**\*MANDATORY SERVICE BULLETIN\*****NUMBER:** SB11-07**REVISION:** 00**DATE:** 07/01/2011**SUBJECT:** Nose Gear Piston Tube Cap Replacement**EFFECTIVITY:**

KODIAK 100 Series Aircraft, Serial Numbers 100-0046 and 100-0052.

Figure 1-1 – View of the Nose Gear (with expanded view of nose gear piston tube cap)

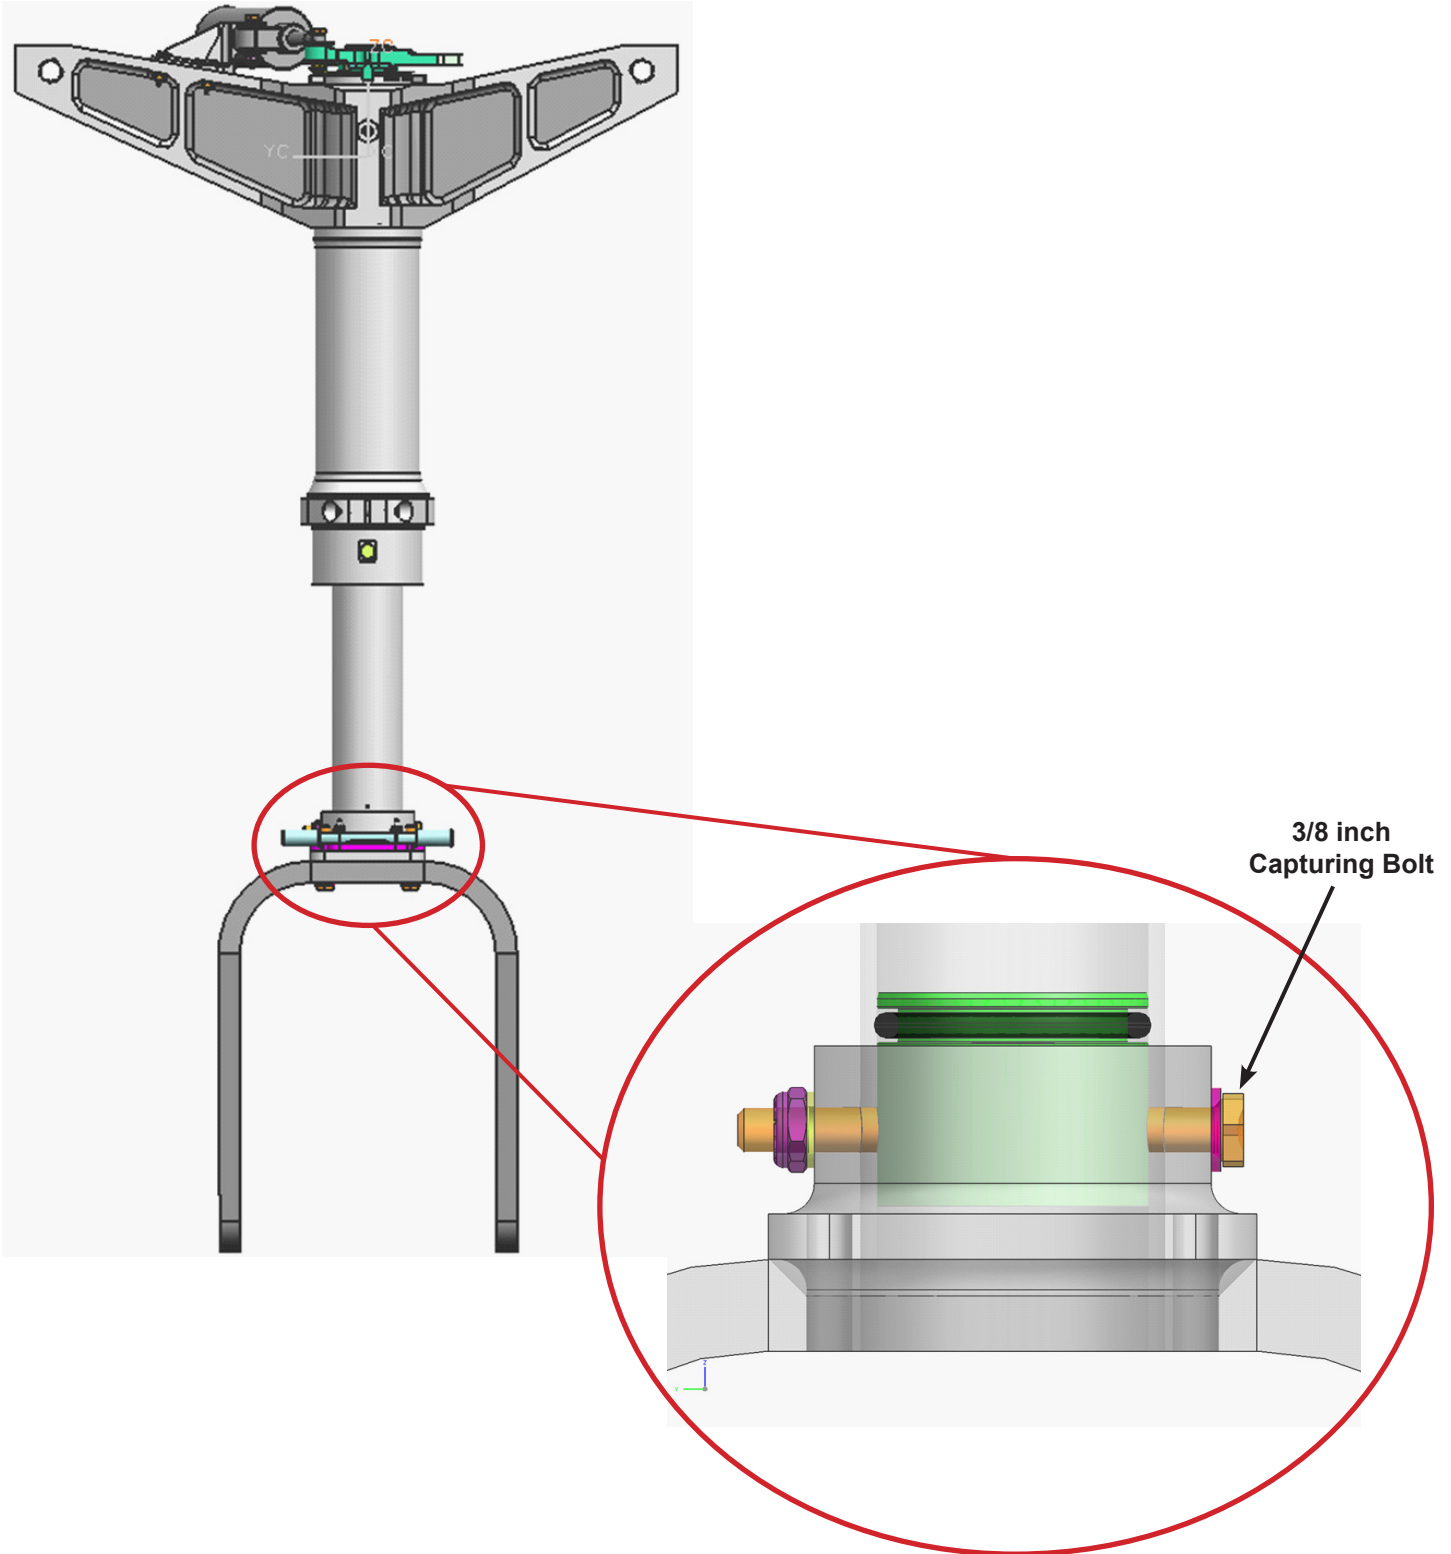
Quest is mandating the replacement of the nose gear piston tube cap on the affected aircraft. Refer to the next part of this Service Bulletin for instructions on how to remove the old nose gear piston tube cap and install the new nose gear piston tube cap.

**NOTE:** In the Figure above, the nose gear piston tube cap (P/N 100-412-0103) is shaded green, and the tow peg and fasteners are removed, for clarity.

Figure 1-2 – Cross Section View Showing Pulling Pin in Place

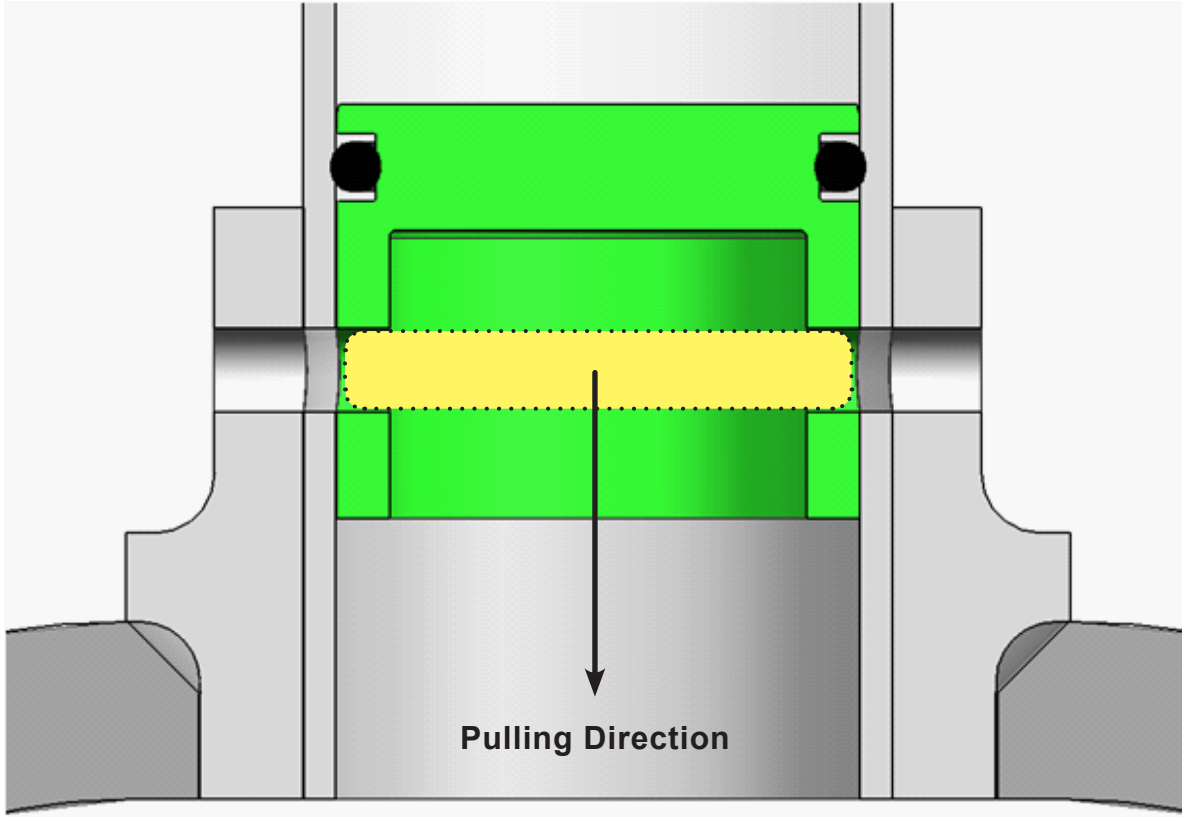
1. Suitably secure and jack the airplane so that the nose wheel can be removed (refer to **Chapter 7** of the *KODIAK 100 Airplane Maintenance Manual*).
2. Remove the nose wheel (refer to **Chapter 32** in the *Airplane Maintenance Manual*).
3. Bleed pressure off of the nose gear using the high pressure air valve.
4. Remove the capturing bolt from the nose gear piston tube cap (P/N **100-412-0103**). See **Figure 1-1**.
5. Install the shop aid (supplied with this Service Bulletin kit) through the 3/8" capturing bolt hole, as shown in **Figure 1-2**.

Figure 1-3 – Cross Section View Showing Clearance for Pulling Pin

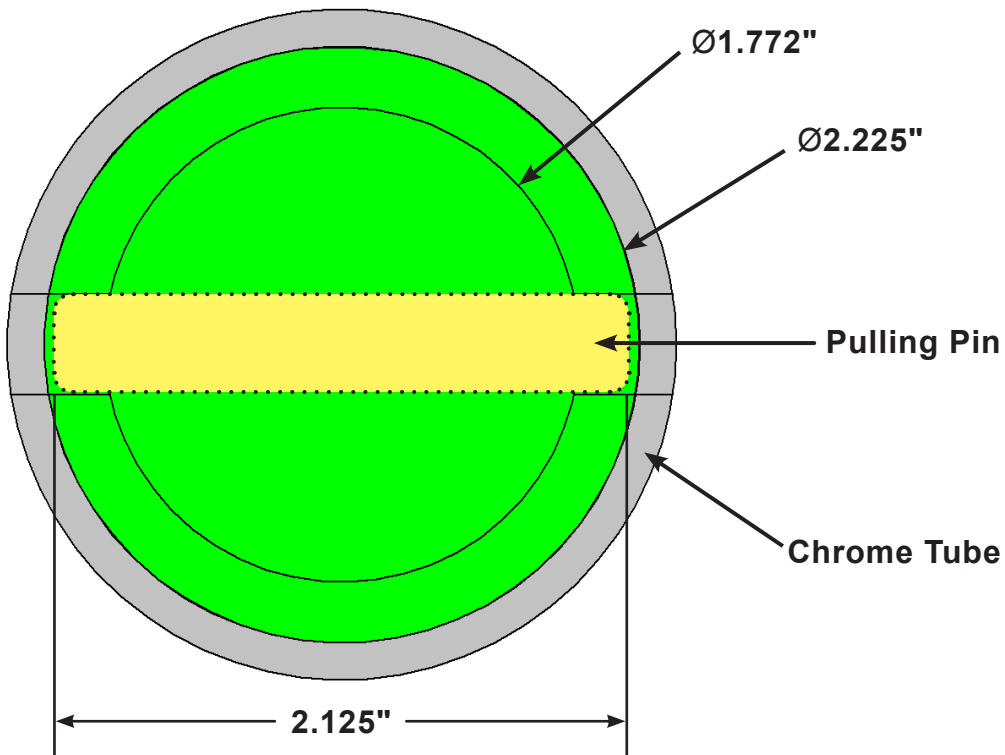
**CAUTION:** To avoid damaging the chrome tube, ensure that the shop aid is centered in the piston tube cap, as shown in **Figure 1-3**.

**Figure 1-4 – Capturing Bolt Installed through the Hole in the New Tube Cap**

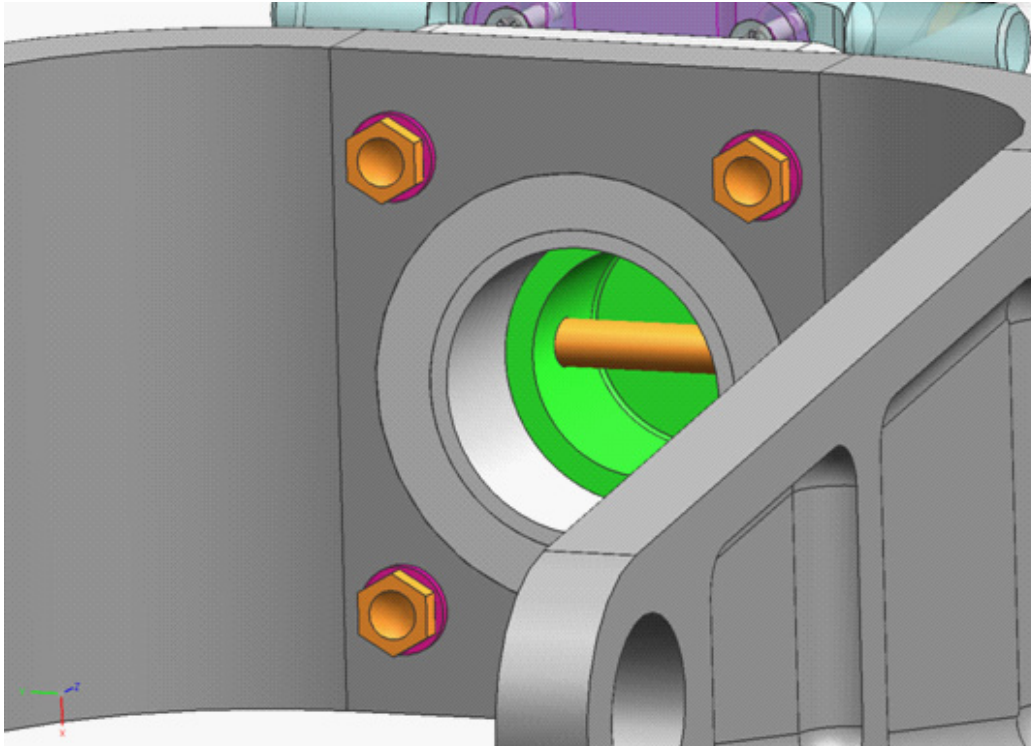
1. Ensure that there are no sharp edges where the 3/8" capturing bolt passes through the inside of the chrome piston tube. If sharp edges are found, deburr appropriately.
2. Install the new nose gear piston tube cap, using Parker lube (or equivalent) and the new supplied O-ring (P/N **M83461/1-328**).
3. Align the hole in the new tube cap with the capturing hole in the chrome tube, and install the 3/8" capturing bolt.
  - A. Looking up through the bottom of the nose gear, ensure that the capturing bolt passes through the capturing bolt hole in the new tube cap. See **Figure 1-4**.
4. Service the nose gear shock strut (refer to **Chapter 12** of the *Airplane Maintenance Manual*).
5. Reinstall the nose wheel.
